# UNITED STATES PATENT AND TRADEMARK OFFICE

APPLICATION NO.	FILING DATE	FIRST NAMED INVENTOR	ATTORNEY DOCKET NO.	CONFIRMATION NO.
10/002,141	12/05/2001	Alexander Beeck	033275-316	3862

**Office Action Summary**

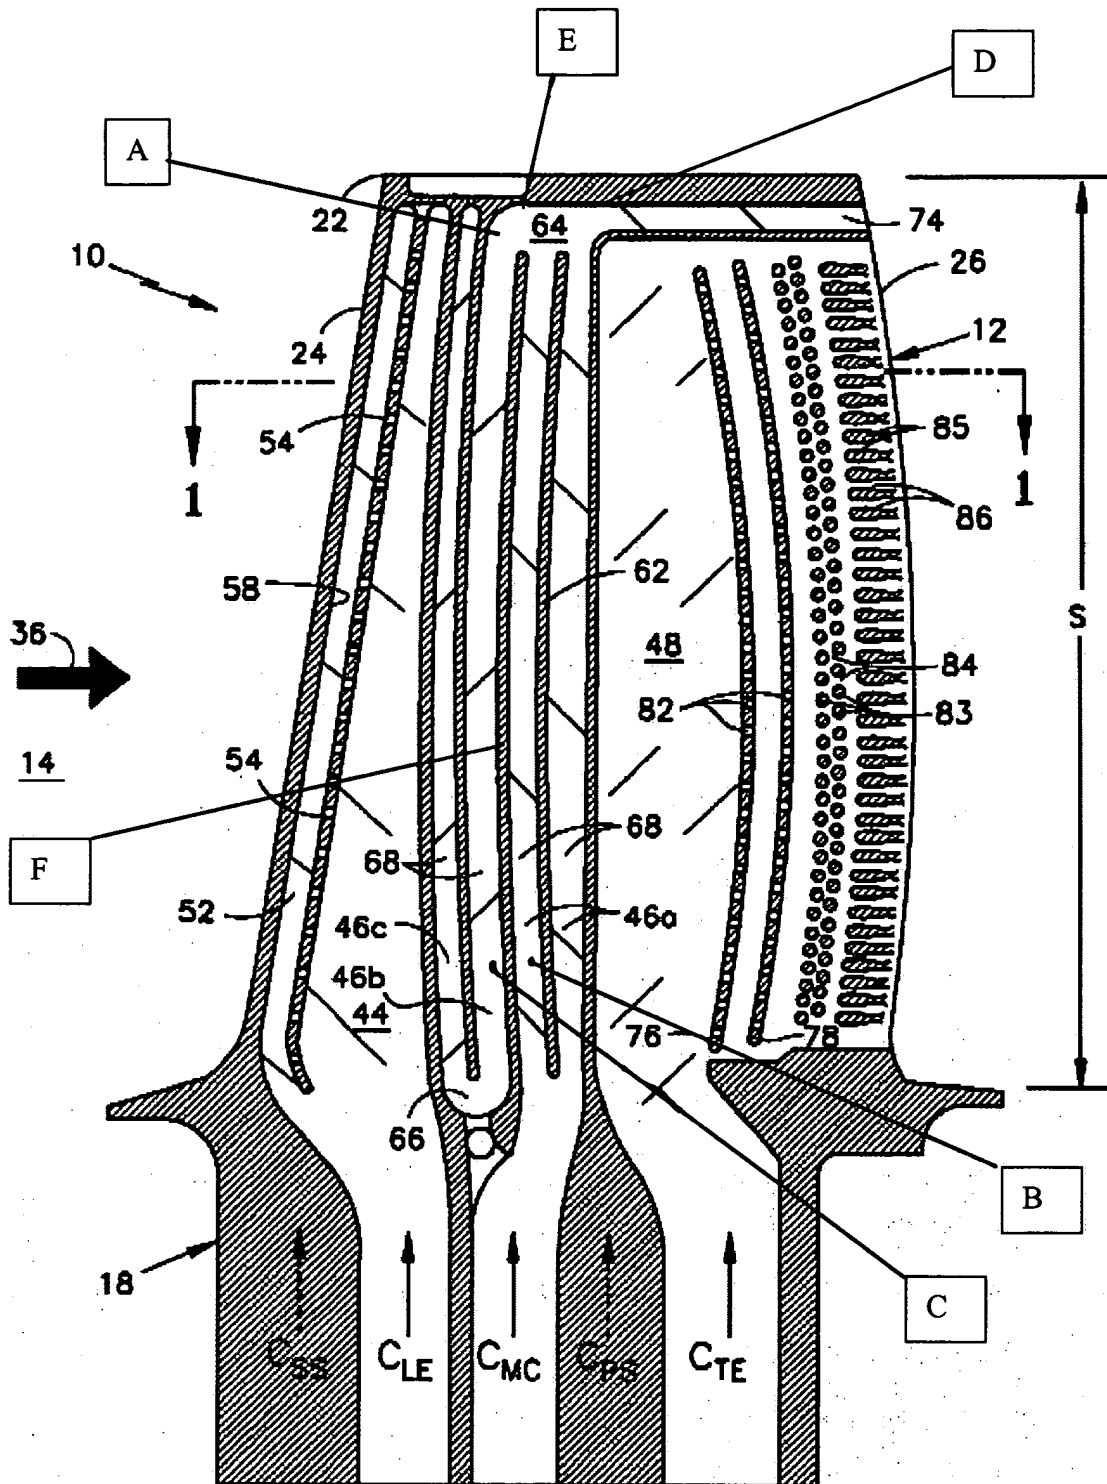
Claims 8, 10-12, and 14-15 are rejected under 35 U.S.C. 102(b) as being anticipated by Krause 5,931,638. Please refer to the annotated figure below. Krause discloses a component 10 of a fluid flow machine, comprising a coolant passage comprising a curved flow section A, a first section B through which a cooling medium flows toward the curved flow section, and a second section C adjacent the first section through which the cooling medium flows away from the curved flow section, and a second passage 74 comprising an unnumbered inspection aperture, the inspection aperture including a top wall D flush with a wall E of the coolant passage, with the second passage branching off the coolant passage at the curved flow section and being arranged

as a tangent to the curved flow section, wherein both of the first section of the coolant passage and the second passage are partially defined by a common surface F. The inspection aperture is arranged and dimensioned to enable introduction of a borescope through the inspection aperture and the second passage. The first section B may be considered as a single first section, through which the cooling medium flows from the coolant passage into the second passage. The coolant passage further comprises a second section C arranged downstream of the curved section, with the coolant passage and the second passage being arranged such that particles entrained in the cooling medium pass through the first section, through the second passage and are discharged through the inspection aperture, while the cooling medium which is relatively free of particles flows through the second section. The second section is adjacent the first section. The recitation of the inspection aperture being arranged and dimensioned to enable introduction of a borescope through the inspection aperture and the second passage does not define over Krause, because these limitations are a function of the size of the borescope, and the size of the borescope would determine whether or not it would be able to be introduced into the inspection aperture. A miniaturized borescope having a tiny diameter would be capable of being introduced into the inspection aperture.
